# G100-12

## 425 (New), Chapter 35

**Jane Malone, National Center for Healthy Housing requests Approval as Modified by this Public Comment.**

**SECTION 425**  
**RADON REDUCING CONSTRUCTION FEATURES FOR GROUP R-2 OCCUPANCIES.**

**Figure 425.1 EPA Map of Radon Zones**

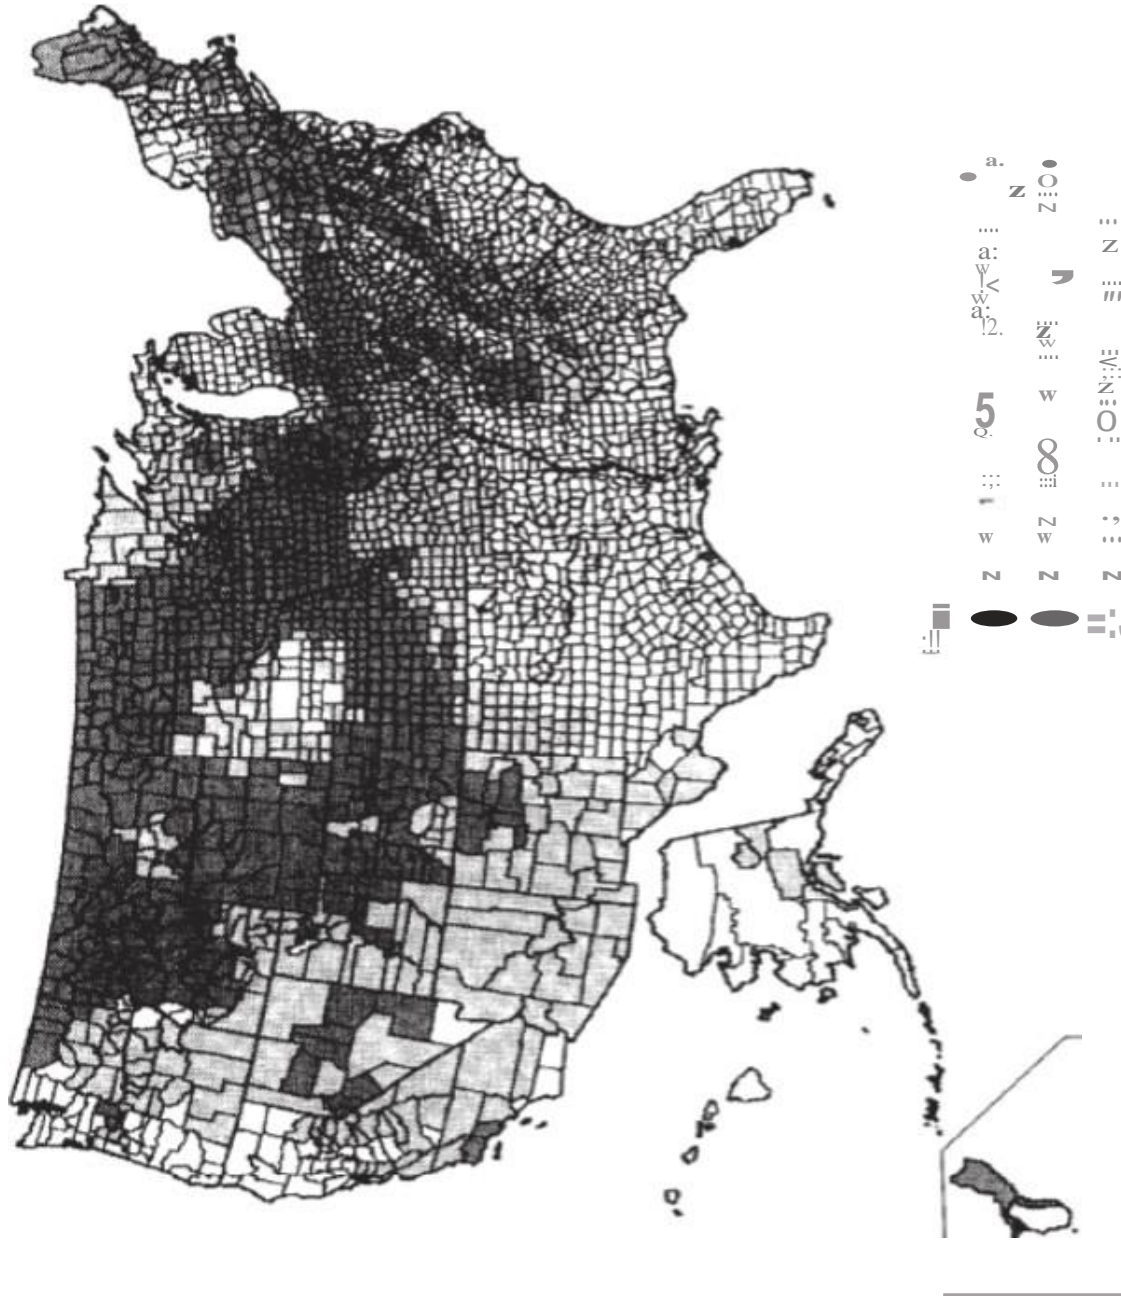
- (2) "The map should be placed within the provisions versus simply referencing the IRC." Response: The EPA Radon Map and county list are included in the proposal as modified, and we have added a provision allowing the code official to approve the use of state and local data to supersede the older EPA information.

**425.1 General.** Buildings containing Group R-2 Occupancies shall comply with the provisions of this section where the building is located in a Zone 1 radon potential area as determined by Figure 425.1 and Table 425.1.

**Exception:** Where approved, radon zone designations or maps adopted by a state agency shall supersede Figure 425.1 and Table 425.1.
